**PR/1370/22**

## Record of Executive Business and Chief Executive's Order

**Reg. Reference:** SDZ21A/0023      **Application Date:** 20-Dec-2021  
**Submission Type:** Clarification of      **Registration Date:** 30-Sep-2022  
Additional  
Information

**Proposed Development:** 455 residential units (including a mixture of 2 and 3 storey semi-detached and terraced houses, and duplex units and apartments in 3 and 4 storey blocks), new internal roads and footpaths, site access, public open space, car parking, cycle stores, landscaping, bin stores, foul and surface water drainage, boundary walls and fences, ESB substations and all associated site development works. Private and semi-private open space to serve the proposed units will be provided in the form of balconies, terraces and gardens; including revisions to the permitted / under construction Celbridge Link Road (part of Loop Road 3), permitted under Reg. Ref SDZ17A/0009, associated with the provision of access to the development, parallel parking bays, and public lighting; 58 two bed, two storey, terraced houses (Type E1, E2, E3, J1 & J2); 6 three bed, two storey, semi-detached houses (Type 11); 190 three bed, two storey, te

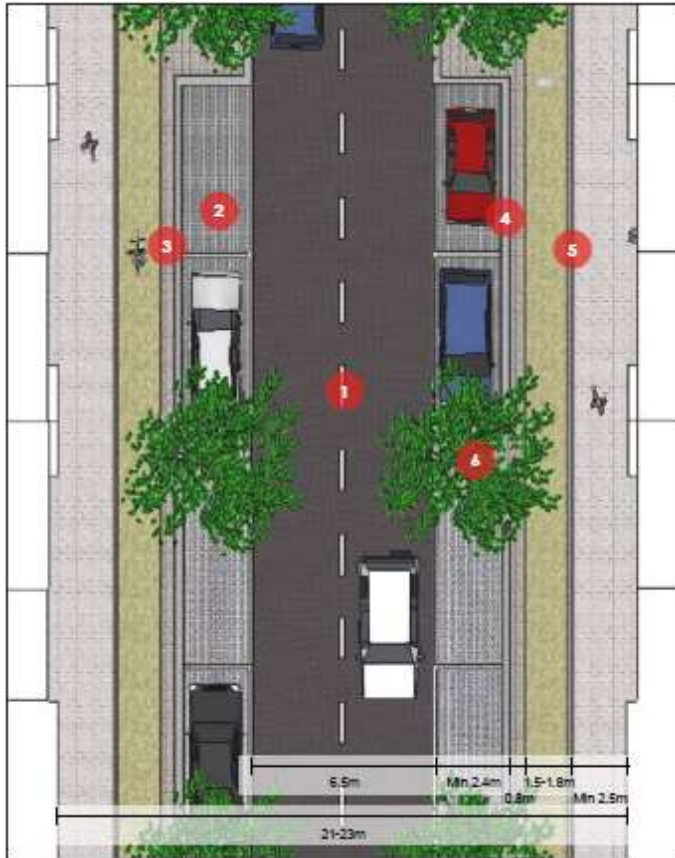
As discussed, the applicant has provided a number of street types across Phase 3. The Avenues are fixed; however, the applicant site incorporates areas with the Avenues, i.e., the south side of Shakleton Drive and the parking areas etc. east / west of the Celbridge Link Road.

It is noted that not all elements of the Avenues are in keeping with this design and the applicant is requested to provide a revised layout indicating that all elements of the Avenues provide parking, trees, footpaths and cycle paths in line with the ASDG. **Additional information.**

*Figure 1 SDZ road layout and proposed layout*

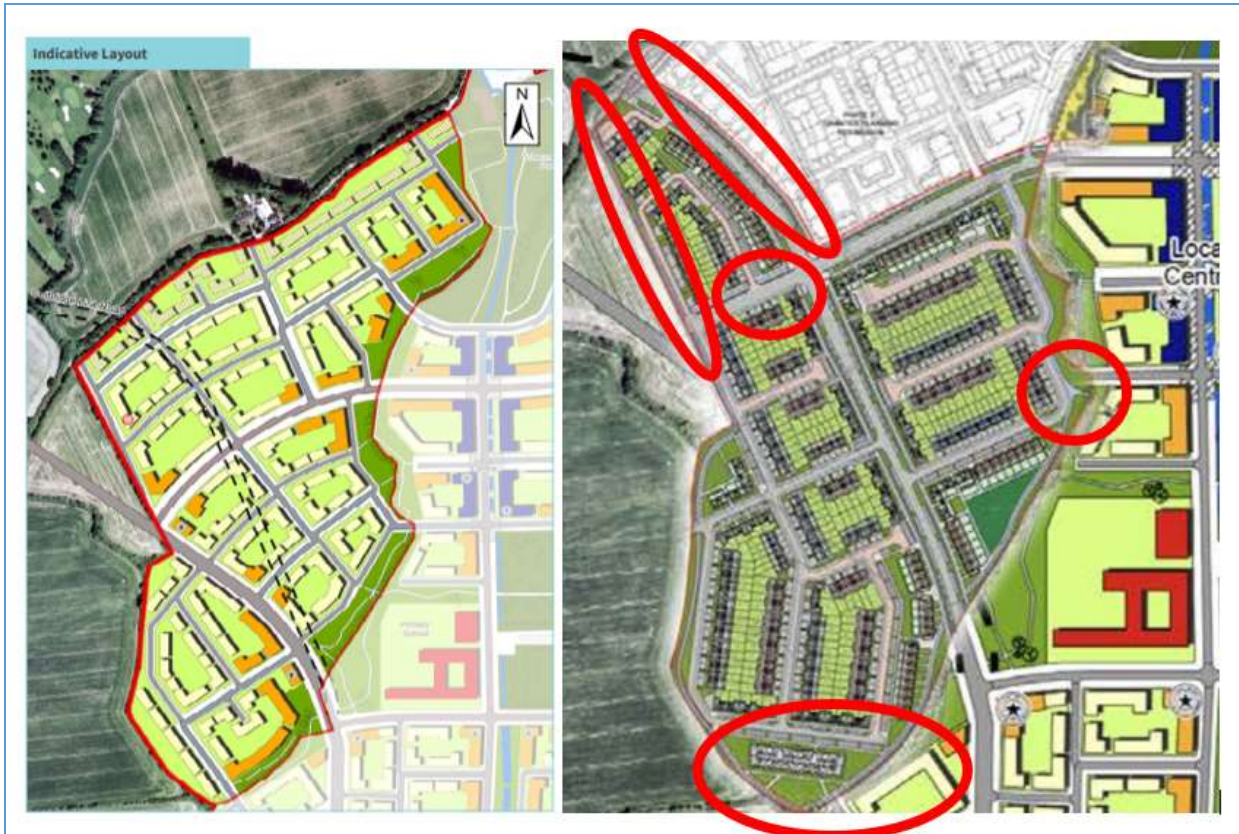
*The main vehicle access locations are from the Celbridge link road running north south. There is another major access from the Adamstown Boulevard from the east. The access links provided for in SDZ17A/0009 should correspond to the access points identified in this development. The street cross sections should match the proposed Celbridge Link Road and follow the layout as approved i.e., on street parking bays, cycle lanes etc.*

Figure 2 road layout from SDZ17A/0009

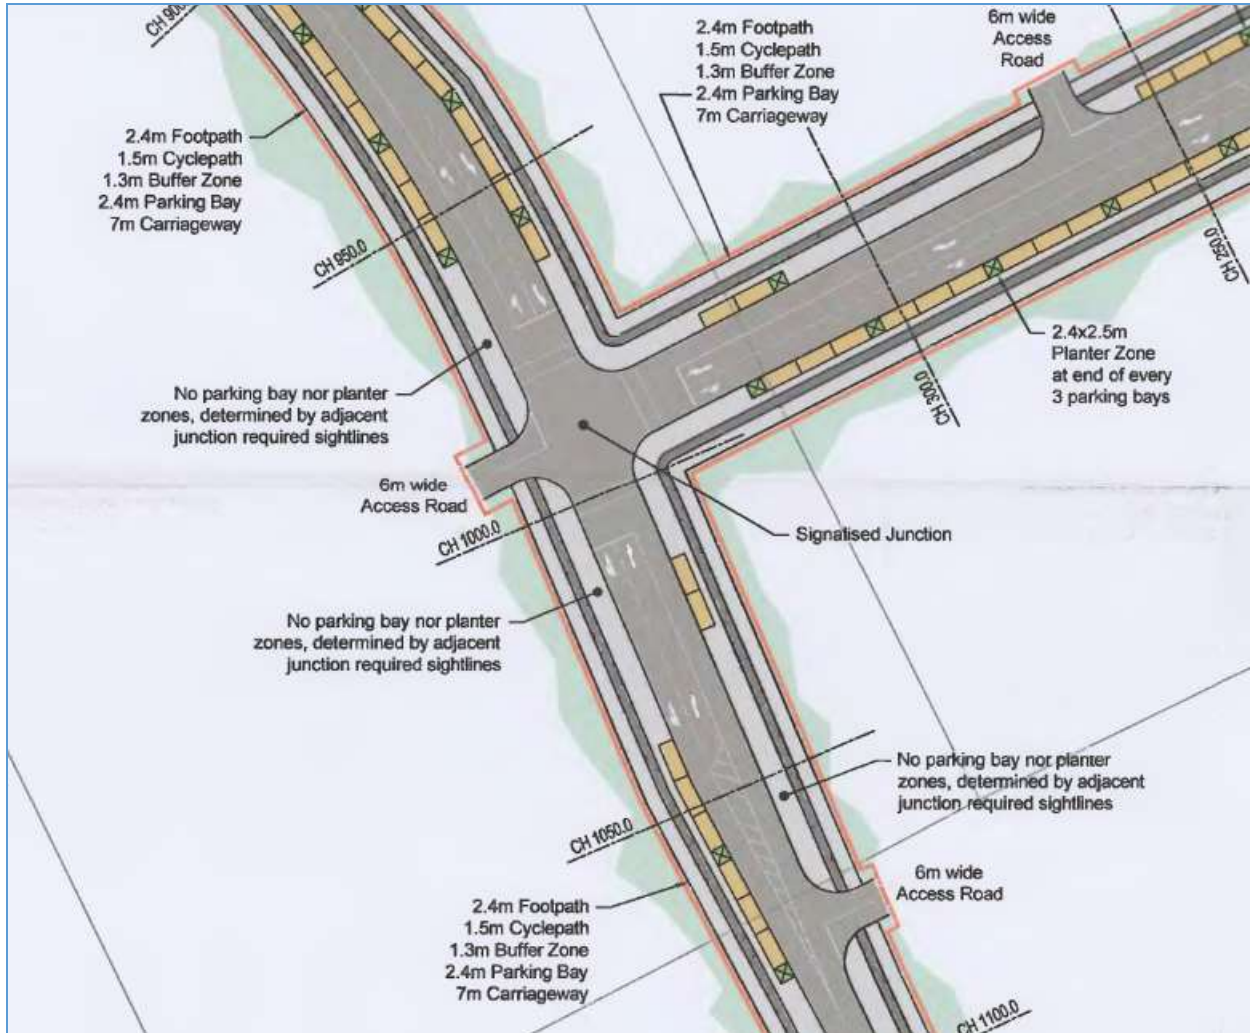
The internal road layout has been provided. The applicant should provide the road cross sections for each road type and ensure the design of roads and streets within the Adamstown SDZ are in accordance with DMURS. Cross section for each road type should ensure correct spacing for cycle lanes and parallel and perpendicular parking. The details of access roads and crossing points should also be submitted showing dimensions of corner radii, road widths etc.

Figure 8 Bike shelter

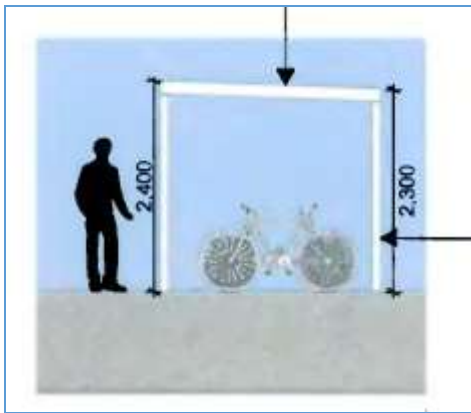
Details of bicycle parking shelters has been provided, Figure 8. The location of the shelters has also been provided. The applicant should provide a statement on the quantity of bicycle parking provided at the development, to ensure the amount is consistent with the apartment guidelines.

*Figure 9 Taking in Charge map*

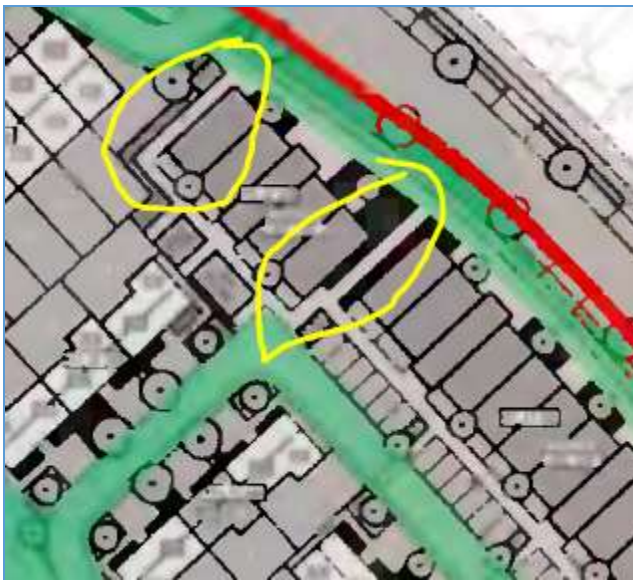
*A taking in charge drawing has been submitted detailing the areas for public care. All the parking spaces and apartment areas are to be maintained by management company. The submitted map highlights the areas for Taking in Charge in green. Figure 9 below shows footpath links (highlighted) are not to be offered for Taking in Charge, this could be clarified.*

*Figure 10 Updated RMDA communal open space diagram*

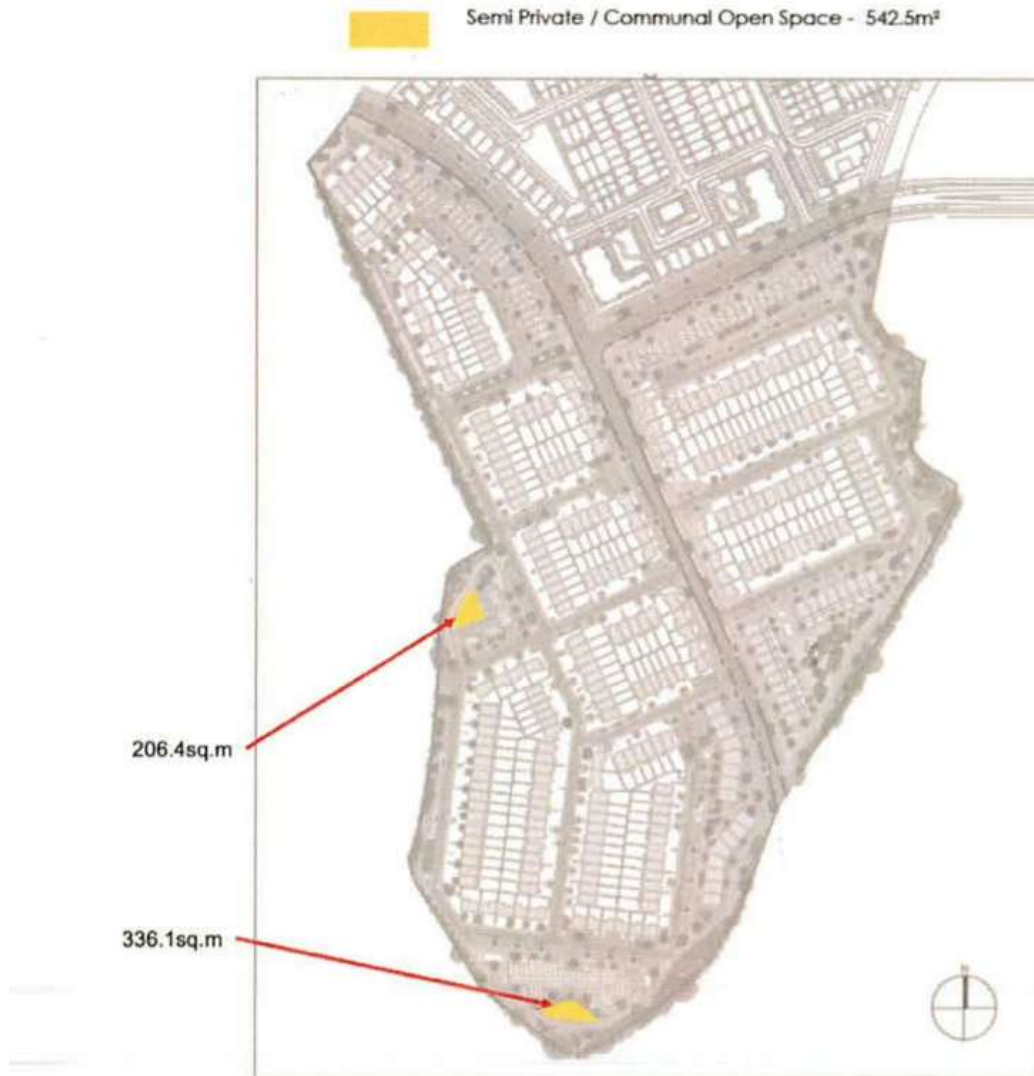
(A) The applicant is requested to provide a breakdown of the communal amenity space and how it accords with the apartment guidelines.

(B) The applicant should note that the Planning Authority has concerns regarding the functionality of some of the areas of open space identified.

Block F: Area to the west appears to consist of trees, bin stores and plant, with no room for amenity space. Area to the east contains a bike store and trees, with no room for amenity space.

Block L: The area identified is a thin strip which is unlikely to provide any amenity.

The applicant is requested to provide revised plans, indicating usable, well connected and functional open spaces.

5. Unit 449 is a wide front house type and benefits from a large garden. This provides a comfortable degree of separation from the adjacent bike and bin store, so amenity of the residence is not impaired. Access to the store is from the front so as to remove any impact on the surrounding residences in terms of both use and management.
